### **REMARKS**

This is a preliminary amendment to be entered with a Request For Continued Examination, and represents a full and timely response to the Advisory Action mailed on July 2, 2004 and the final Office Action mailed on April 9, 2004. Through this preliminary amendment, claims 1, 4-5, 11, 14-16, 23-25, 28-30, and 35-37 have been amended, and claim 31 has been cancelled without prejudice, waiver, or disclaimer. Reconsideration and allowance of the application and pending claims are respectfully requested.

#### **I. Objection to Drawings**

FIGURE 3A

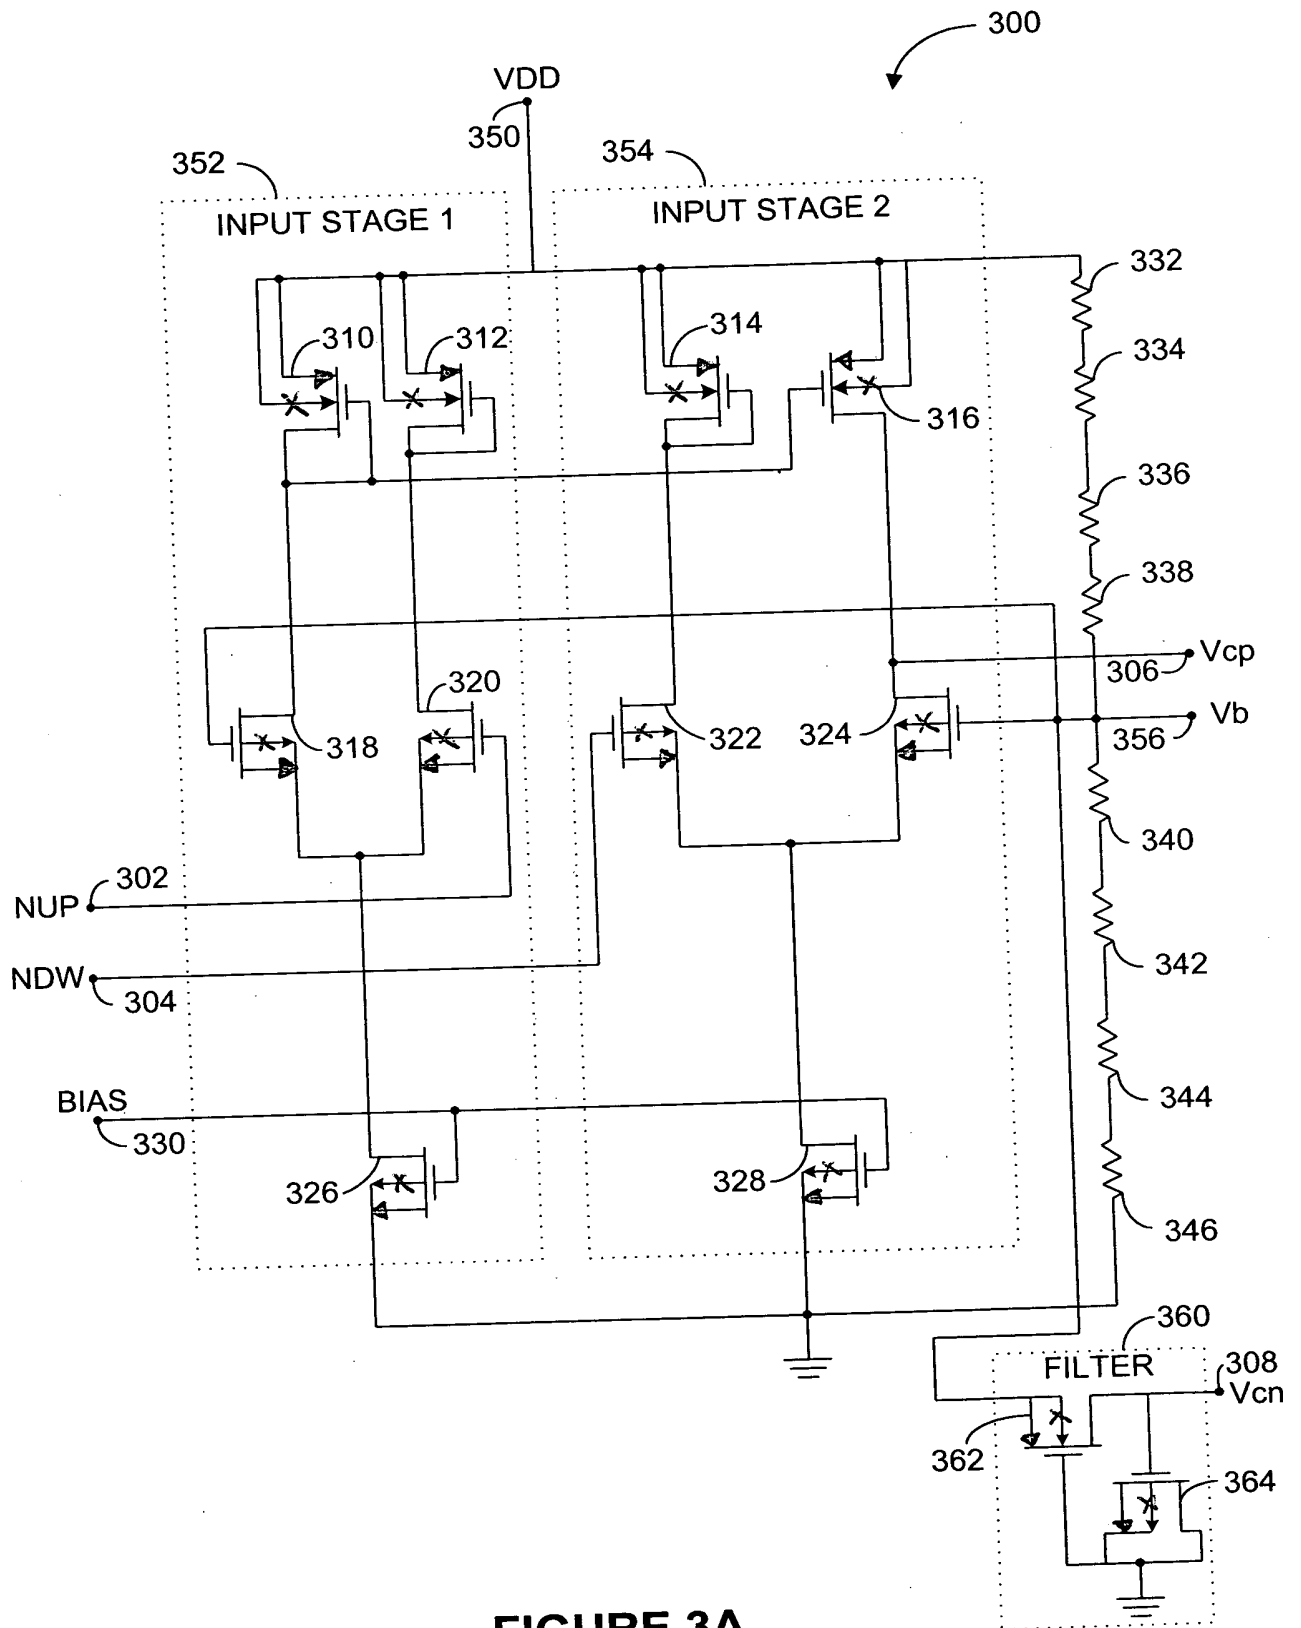
Examiner has considered Applicant's remarks for the drawing objection and has not found them to be persuasive. Contrary to Applicant's remarks, it would have been clear to one skilled in the art that, due to the direction of the area, the transistor 362 of Figs. 3A and 3B is in fact shown as an N-channel and that transistor 364 is in fact shown as a P-channel. Similar, due to the direction of the arrows for the remaining transistors, such are deemed to be improperly shown. Thus, the drawing objections have not been overcome.

Relating the above to a couple of examples of transistors represented in Applicant's drawings, please refer to FIG. 3A, transistor 362. As shown, the transistor 362 takes on a configuration as shown in Exhibits A and B for PMOS transistors. In other words, the arrow representing the substrate is pointing toward the gate, from source to drain. The fact that the source is from the voltage divider side (*e.g.*, from resistor 346) is reflected in the specification on page 14, lines 1 and 2. Thus, transistor 362 is shown in one embodiment as a P-type, enhancement mode transistor where the substrate is connected to the base.

As another example, please refer to FIG. 3A and transistor 364. Transistor 364 takes on a configuration as shown in Exhibits A and B for an NMOS transistor. That is,

the arrow points away from the gate, in a direction from drain to source. Such a configuration is known to those skilled in the art as an enhancement mode NMOS transistor where the substrate is connected to the body.

Applicant has amended the figures to comport with enhancement mode transistor designations where the body is connected to the substrate, as disclosed in several embodiments of Applicant's application. Additionally, Applicant has enclosed Exhibits A and B for the convenience of the Examiner and to support the drawing changes that have been made. Exhibit A includes two pages from a textbook used in a course presented at a university campus on analog and digital based microelectronic circuit

Thus, in that the drawings comport with accepted practice in representing transistors, Applicant respectfully submits that the objection to the drawings has been overcome. Further, Applicant respectfully requests that the drawing objections be withdrawn.
